IETF Network Slice Service YANG Model

[draft-ietf-teas-ietf-network-slice-nbi-yang](#)

July 2023 (IETF 117)

Summary of issues addressed since IETF116

Figure 4: Network Topology with CEs and ACs

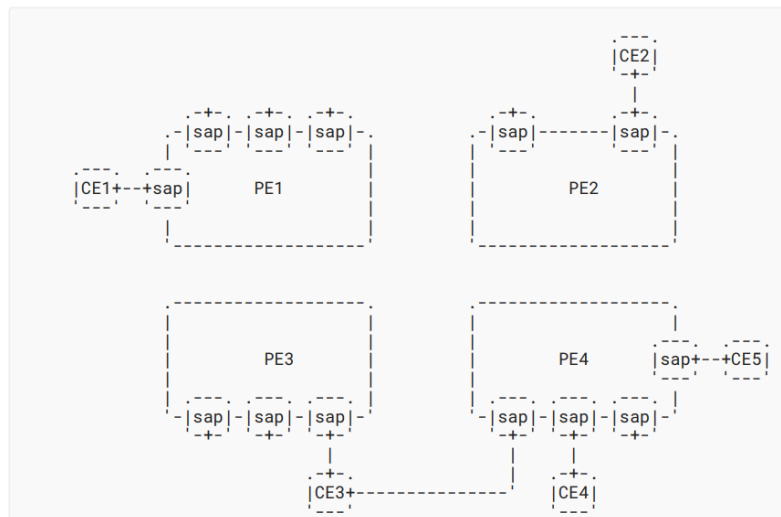
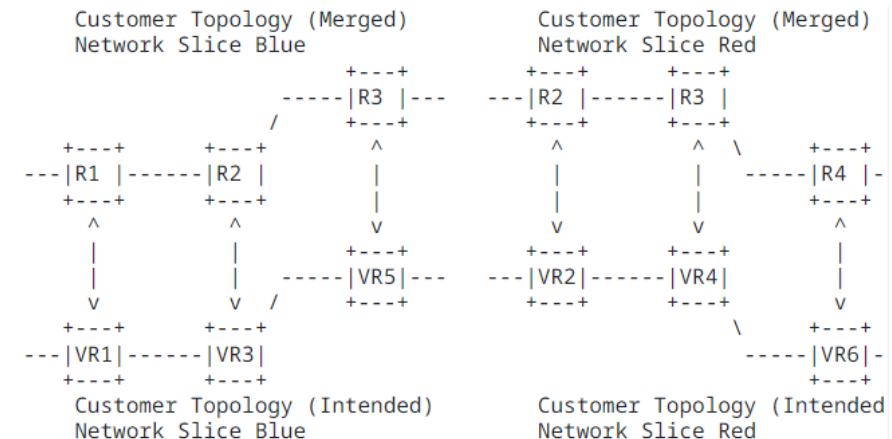
Issue#1 Custom topology definition

- Currently our NBI Yang model has an attributed "**custom-topology-ref**" which refers a prebuilt network topology
- **Issue:** Rather than a reference, [draft-liu-teas-transport-network-slice-yang](#) augments RFC8345 to the NS Service Model.
 - However, new [draft-boucadair-teas-ietf-slicing-overview](#) suggests the reference is useful for SAP (RFC9408) as a customized topology
- **Proposal:** Keep current attribute "**custom-topology-ref**" since it is flexible for SAP or VN or other abstract models as the custom topology.
